# PIC18F27/47/57Q43 Silicon Errata and Data Sheet Clarifications

The PIC18F27/47/57Q43 devices you have received conform functionally to the current device data sheet (DS40002147G), except for the anomalies described in this document.

The silicon issues discussed in the following pages are for silicon revisions with the Device and Revision IDs listed in the table below.

**1.7.1 UART TXDE Signal May Go Low before the STOP Bit Has Been Entirely Transmitted**

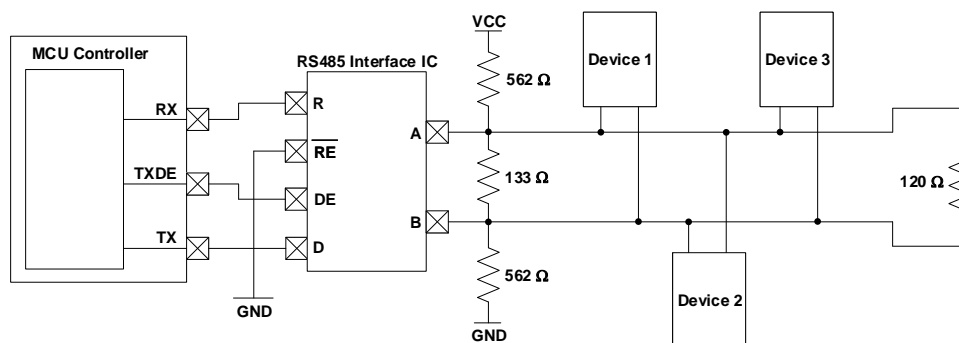
The UART Transmit Drive Enable (TXDE) signal could potentially transition into a low state before the UART STOP bit has been entirely transmitted due to the effects of parasitic capacitance on the TX line. In some applications, this could result in communication being prematurely terminated due to the TXDE bit going low before the STOP bit has had enough time to settle.

To ensure that the STOP bit settles into its final logic state before the TXDE signal transitions low, a biasing circuit can be implemented. A biasing circuit allows the TX line to either be driven high or low, rather than being left in a floating tri-state mode where prolonged rise or fall times could lead to communication being disrupted. This bias circuit should only be implemented on one end of the serial bus, and a termination resistor should be used on the other end. The figure below shows an example of a bias circuit that can be used to achieve this.

Please note that the resistor values used in this circuit are recommendations and that the actual resistor values required may vary based on the application.
